**Project #20-056
DE LA RU Building Addition
Located at 1750 North 730 West**

<i>Project Name:</i>	DE LA RU Building Addition
<i>Proponent / Owner:</i>	Courtney Wallace (Cartwright AEC, Inc)/GUNHO Logan, LLC
<i>Project Address:</i>	1750 North 730 West
<i>Request:</i>	Design Review Permit
<i>Current Zoning:</i>	Industrial Park (IP)
<i>Type of Action:</i>	Quasi-Judicial
<i>Hearing Date</i>	November 12, 2020
<i>Submitted By:</i>	Tanya Rice, Planner II

Staff recommends that the Planning Commission **conditionally approve** a Design Review Permit for Project #20-056, DE LA RU building addition, in the Industrial Park (IP) zone located at 1750 North 730 West, TIN #07-176-0015.

Figure 2 shows the proposed site plan

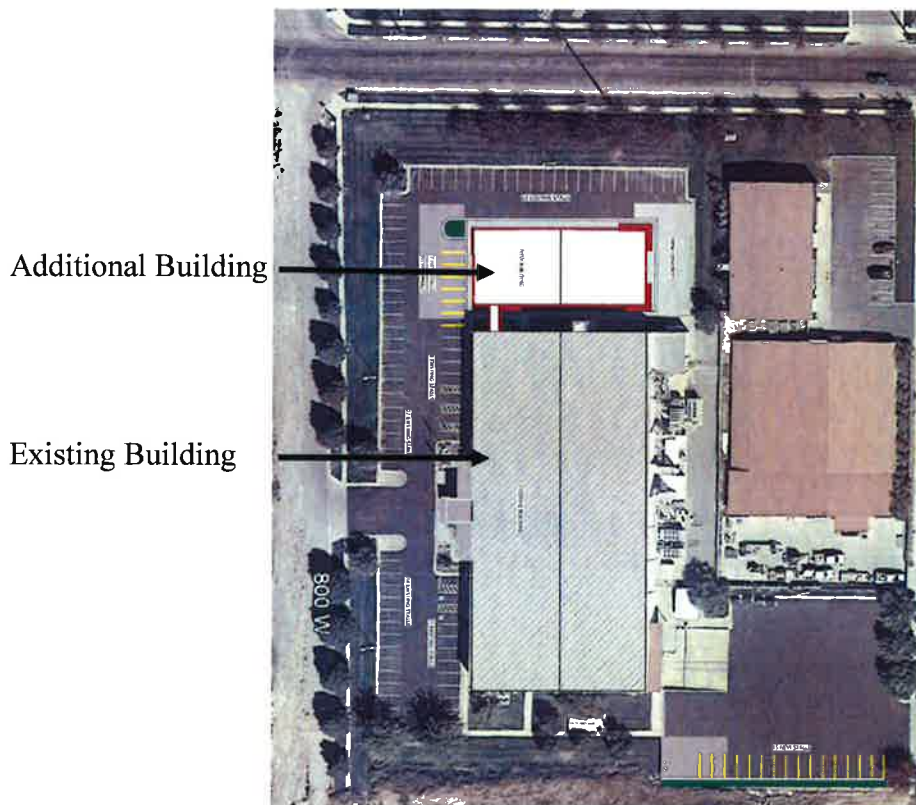
Front (West):	100'
Side (North):	85'
Side (South):	NA
Rear (East):	45'
Parking Side (North):	40'
Parking Side (Southeast):	~7'

As conditioned, the project meets the minimum setbacks with the exception of the southeast parking which needs to be adjusted to 15'.

1. All standard conditions of approval will be recorded with the Design Review and are available in the Community Development Department.
2. The additional parking on the southeast corner of the property shall to be set back to 15' off the property line.

- a) Parking lot perimeter landscaping along the southeast parking stalls.
 - b) Replace the five trees removed from the north parking lot.
 - c) Planting strip along the north and west sides of the new building.

- Conditions of approval: Need a fire apparatus turn-around at the end of the fire access lane on the North side of the building.
- Access
 - (IFC 503.1.1) *Fire Apparatus Access shall extend to within 150 feet of all portions of the facility as measured by an approved route around the exterior of the building.*

- New building creates a long fire access lane along the west and north of the building that is longer than 150' without a fire apparatus turn-around.

EXTERIOR
ELEVATIONS

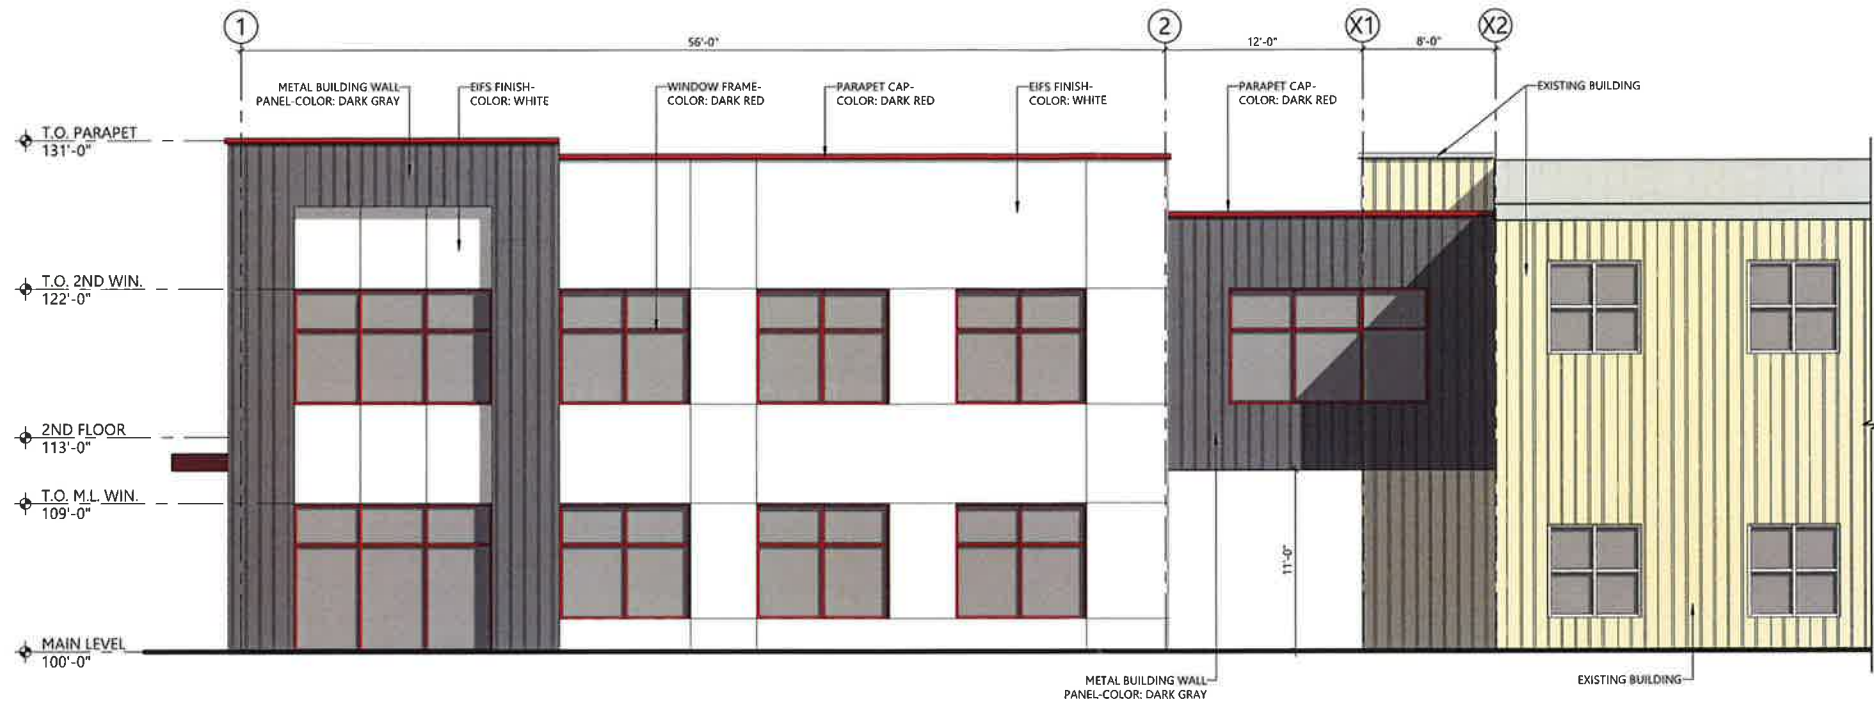
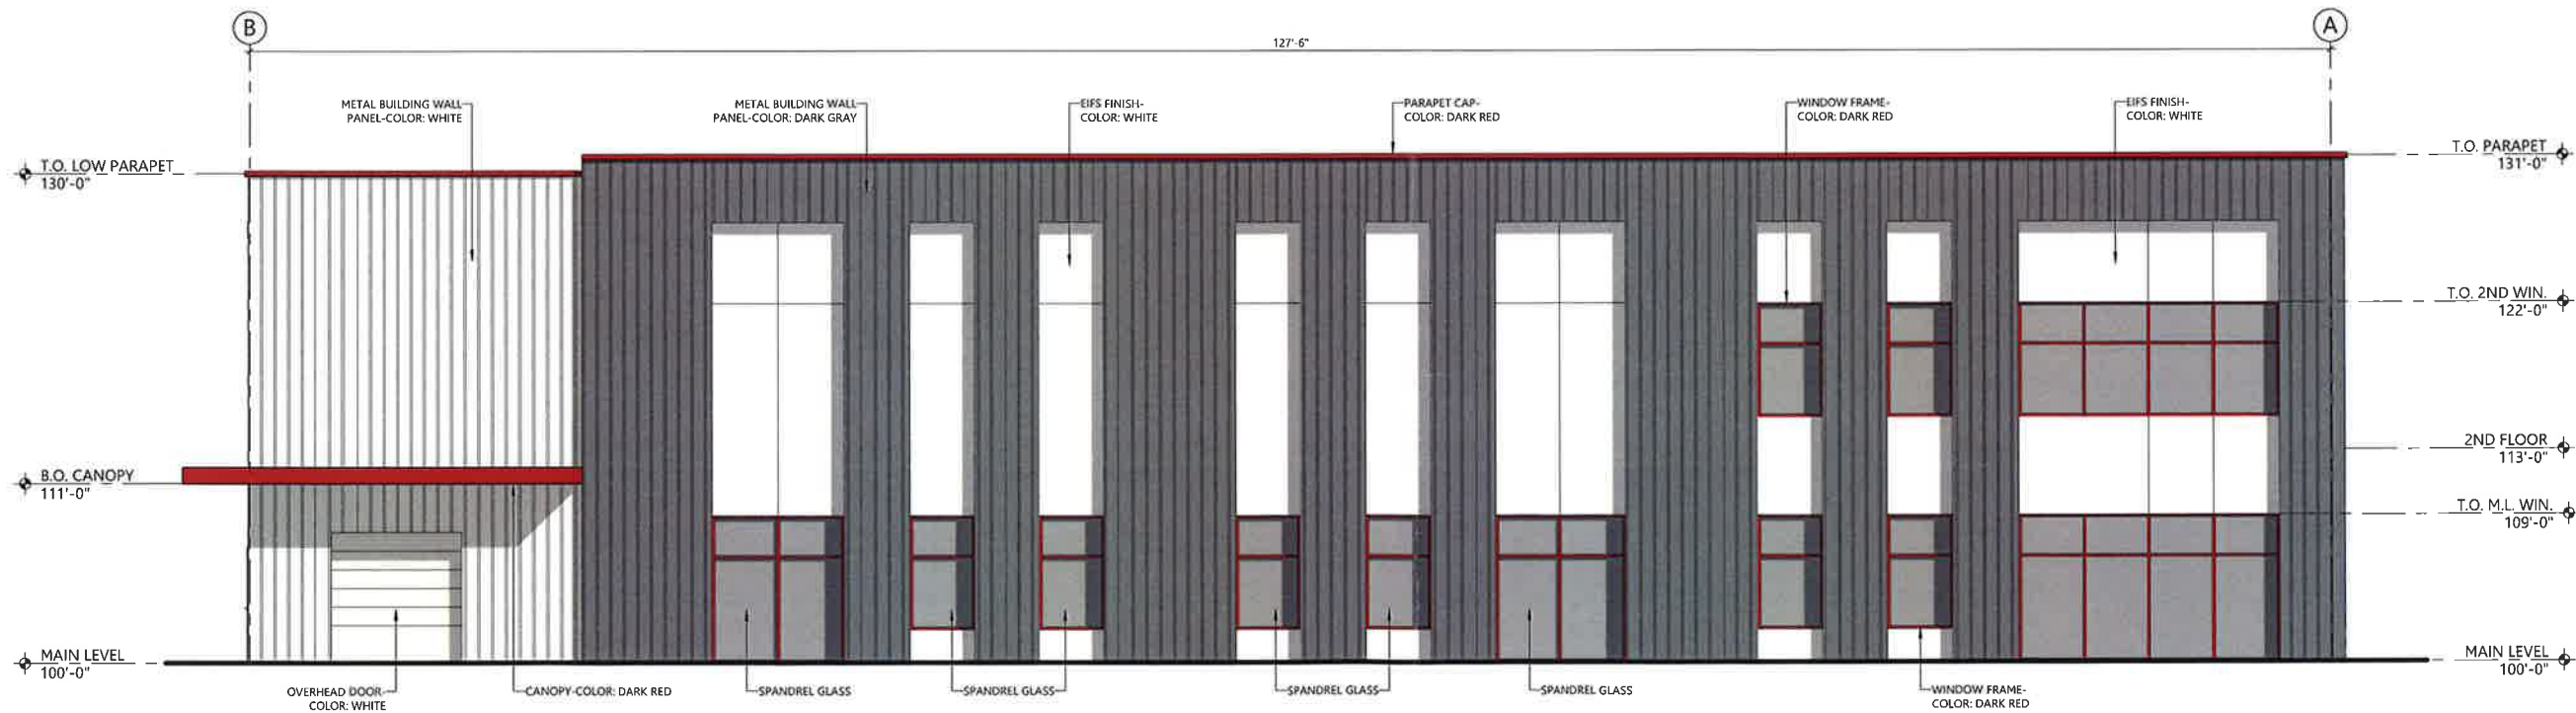
Figure 2 shows the proposed front (west) façade and side (north) façade both visible from public streets.

West Elevation (800 W Frontage): 32%
